UNITED STATES PATENT AND TRADEMARK OFFICE

APPLICATION NO.	FILING DATE	FIRST NAMED INVENTOR	ATTORNEY DOCKET NO.	CONFIRMATION NO.
10/008,623	12/06/2001	Malcolm R. Schuler	90065.161701	3753

Office Action Summary

DETAILED ACTION

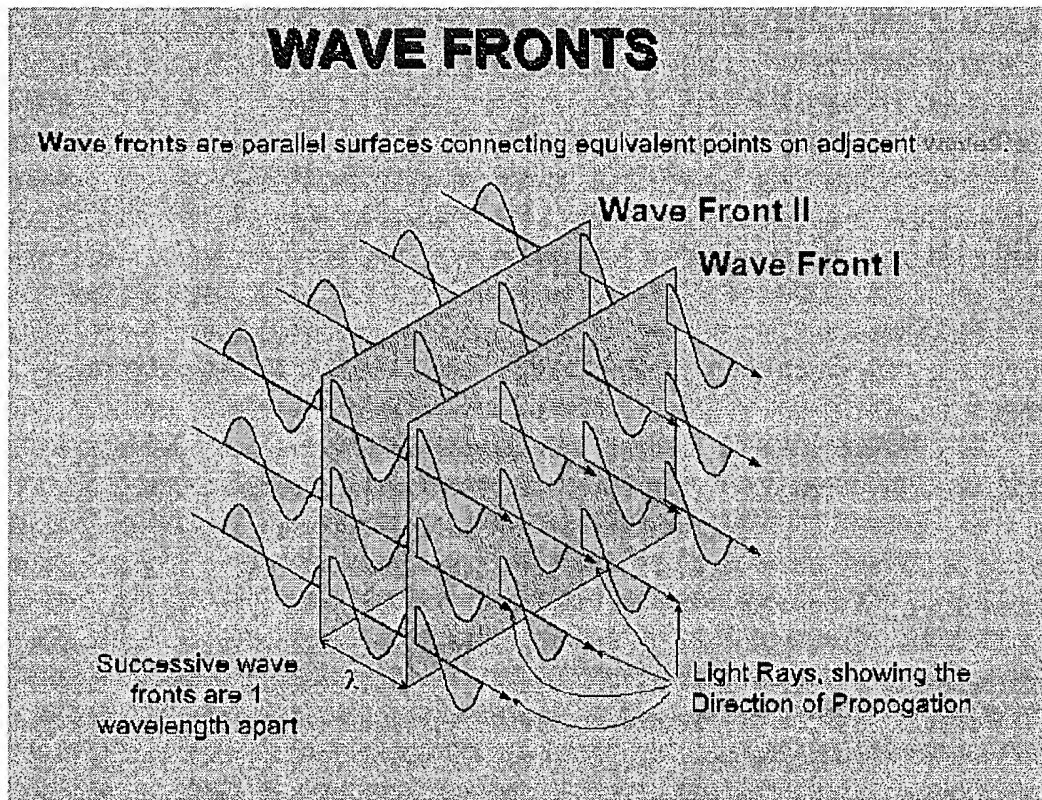
The applicants argue that the rejection of 13, 14 and 15 under 35 USC 112(1) is not proper. The arguments are not persuasive because the applicants in their arguments interpreted "wave fronts" as a direction. The "wave front" is not a direction. Such interpretation contradicts to the meaning of the term. See the definition from the Merriam Webster dictionary presented by the applicants (page 6, lines 15-18 of the Remarks). The original disclosure is silent regarding the "wave front". The original disclosure does not redefine the term.

For better visual presentation the definition of the term from

<http://www.brocku.ca/earthsciences/people/gfinn/optical/wavefron.htm> is presented here:

1. Wave front - parallel surface connecting similar or equivalent points on adjacent waves.
2. Wave Normal - a line perpendicular to the wave front, representing the direction the wave is moving.
3. Light Ray is the direction of propagation of the light energy.

The applicant's attention is directed to the fact that any direction, which would be perpendicular to the direction of travel of the waves (Direction of Propagation on the Figure), would be in the surface defined as Wave Front. Thereby, there is no a direction which is at the same time perpendicular to the direction of travel waves and to the wave fronts.
